Production: **Airmate-Telco**

Modification to correct for varying coil voltage to relay RL2.

Production: **Airmate-USB TELCO MODULE**

Production: **Airmate-USB/Triple input module/Telco module**

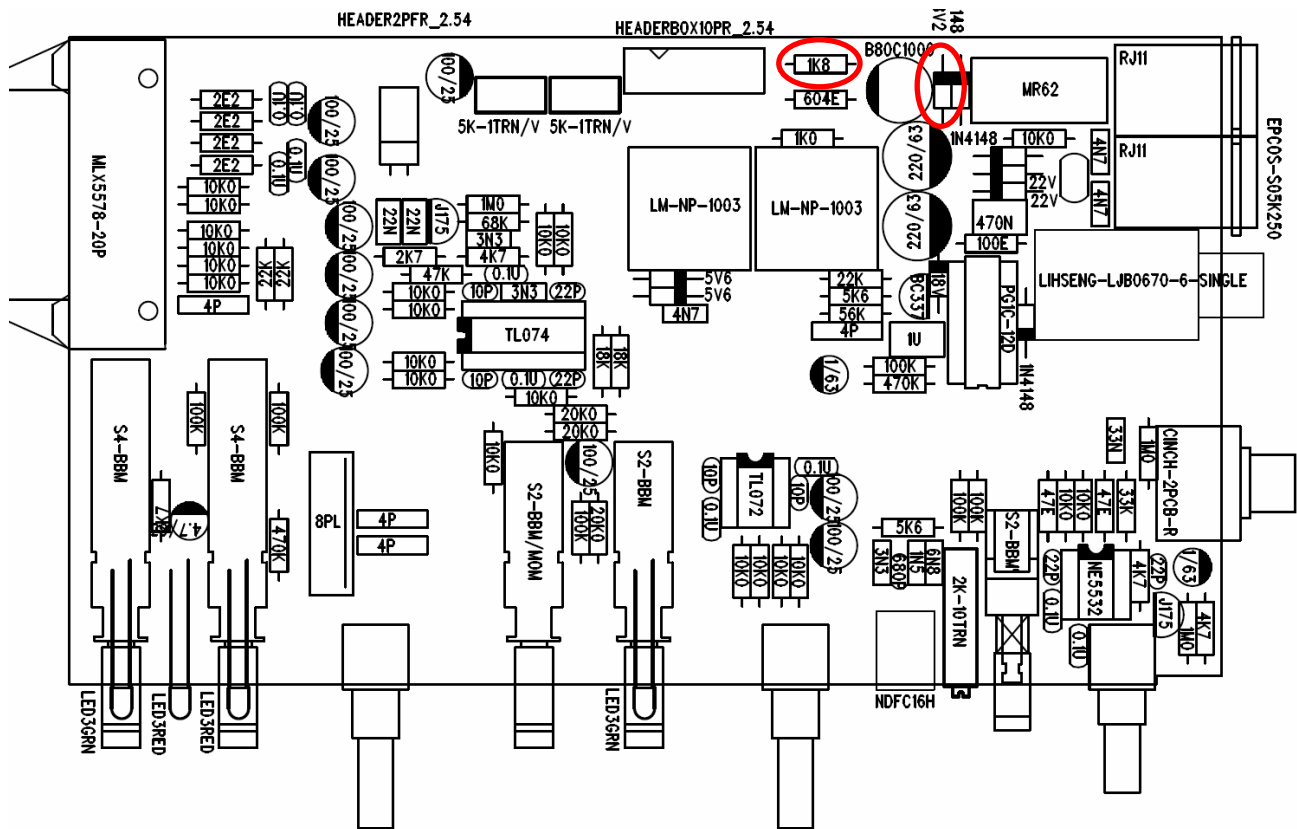
1. Replace the following components during assembly of the PCB.

Part	Old Part	Old Part Number	New Part	New Part number
R6	1K8	10350732	1K5	10350731
Z6	8V2 Zener	10250352	9V1 Zener	10250373

The components are marked with a red circled

Adjustment of Mix-Minus trimmers by end user/engineer in Airmate-USB Telco channel

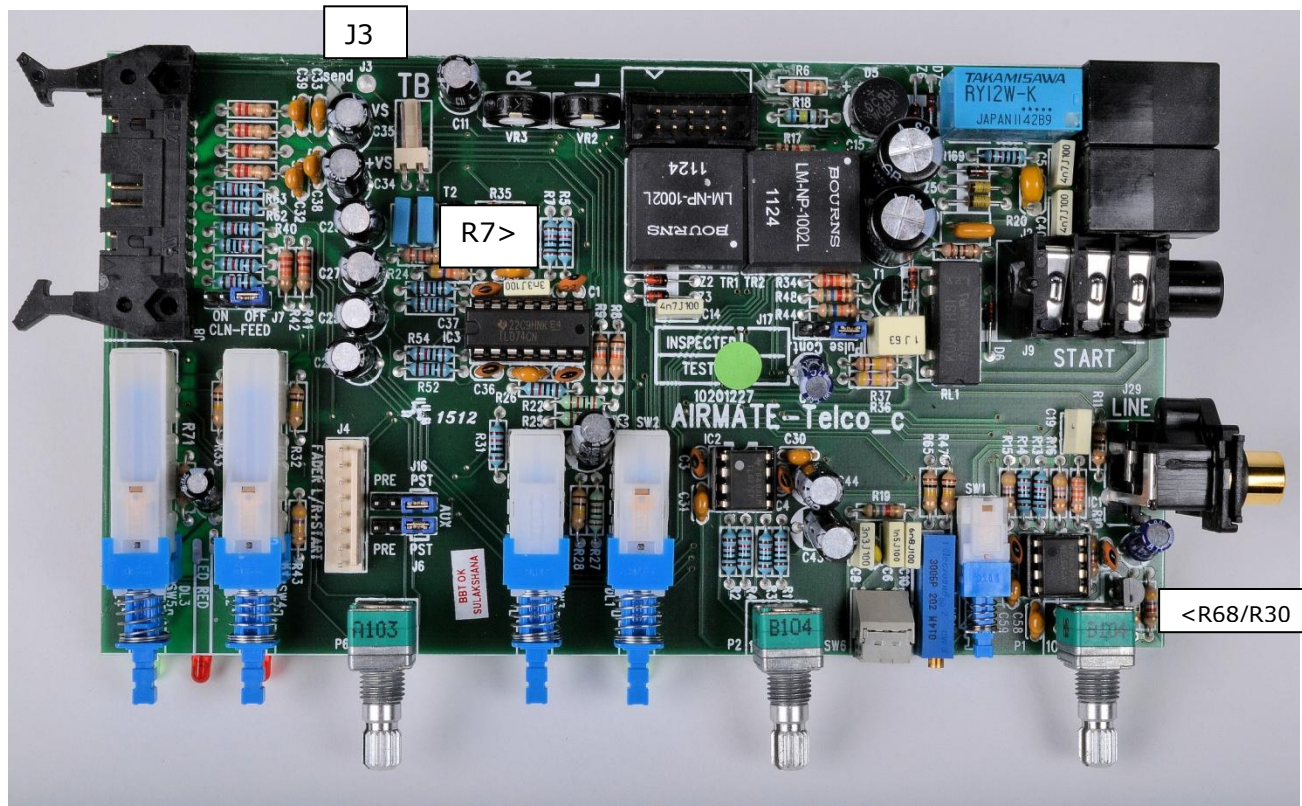
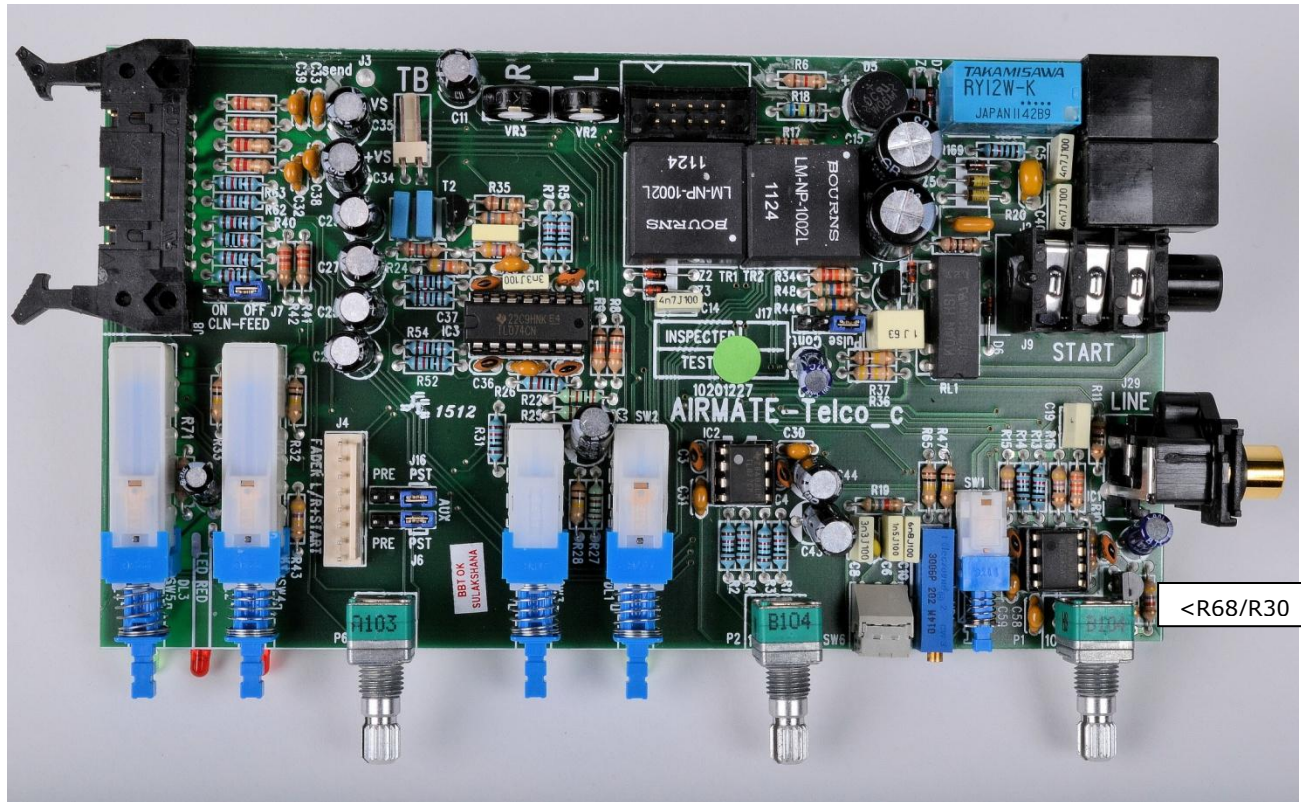
1. Connect a signal (Music or 1kHz tone) to the line input of the TELCO module.
(no other signal anywhere else in the mixer should be fed to the mixer)
2. Select the Line input in the Telco module.
3. Now call the station with your mobile phone.
4. Pick up your own call on the mixer.
5. Listen to your mobile phone and you will hear the signal from the line in of the Telco module pretty low (hopefully)
6. Adjust trimmer VR2 (L) to a minimal heard signal in your mobile phone and do the same with trimmer VR3(R)

1. Connect 1kHz L/R on line-in of the Telco line in module.
2. Put an oscilloscope on test point J3
3. Adjust VR2/3 for minimal signal

Airmate1e: Add a 18K resistor as shown

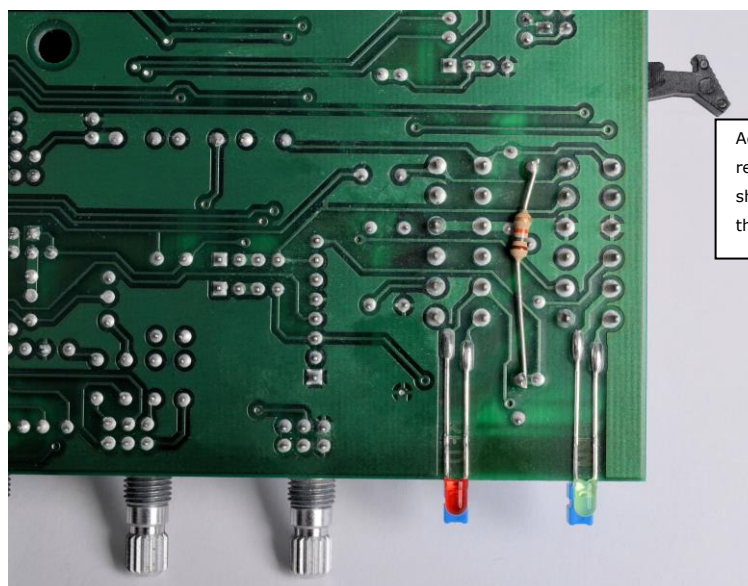
Problem: The fader start gives a secondary pulse when the fader start is activated while the on/off button is in off position.

Cause: C47 (TIM/USB) And C9 (Telco module) isn't discharged quick enough.

Solution: Place a 18K resistor from the negative side of C47 to -VS1 to discharge the capacitor quick enough.
Also change R60 from 390K to 220K to make sure that the MIC on/Self op transistor is turned on properly.
